**BELLWOOD SUBDIVISION, RESUBDIVISION OF LOTS 12, 13 & 14**  
**BLOCK 1 UNIT 9**

APPLICATION NUMBER 18 DATE February 18, 2010

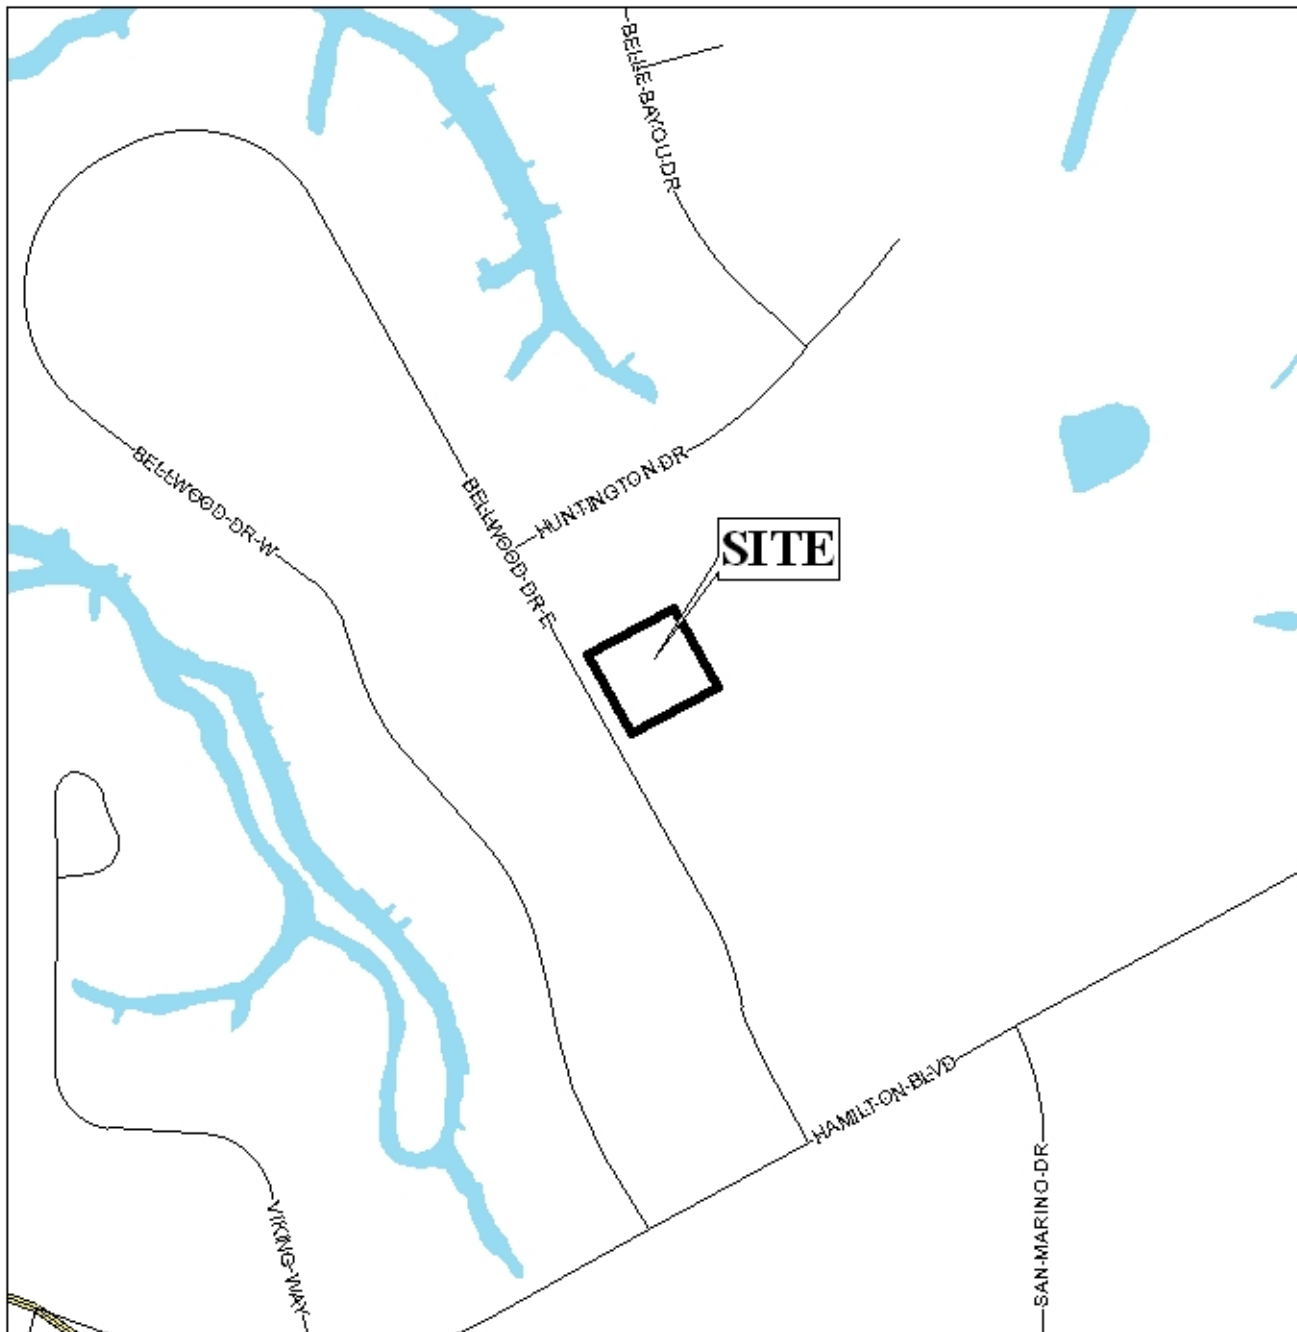
The site fronts Bellwood Drive East, a minor street not providing curb and gutter. Section V.B.14. of the Subdivision Regulations requires right-of-way width of 60' for minor streets not providing curb and gutter. The road is depicted with an inadequate 50' right-of-way, and, as such, dedication of sufficient right-of-way to provide 30' from the centerline of Bellwood Drive East, would be required.

It should further be mentioned that to the rear of the proposed lots is a 60-foot wide unopened right-of-way, Ridge Road. Ridge Road is a dirt road and is not maintained by the county. The site should be denied access to Ridge Road.

As a means of access management, a note should be placed on the plat stating that the lots are limited to one curb-cut each, with the size, location, and design to be approved by County Engineering and in conformance with AASHTO standards.

The sizes of the proposed lots are shown on the preliminary plat, and both appear to meet the minimum size requirements as regulated by Section V.D.2 of the Subdivision Regulations.

The 25-foot minimum building setback line is depicted, and should be retained on the Final Plat, if approved.

- 1) dedication of sufficient right-of-way to provide 30' from the centerline of Bellwood Drive East;
- 2) revision of the lot size information to reflect dedication;

- 3) placement of a note on the Final Plat denying the site access to Ridge Road;
- 4) placement of a note on the Final Plat stating that each lot is limited to one curb-cut with the size, design, and location of all curb-cuts to be approved by Mobile County Engineering and in conformance with AASHTO standards;
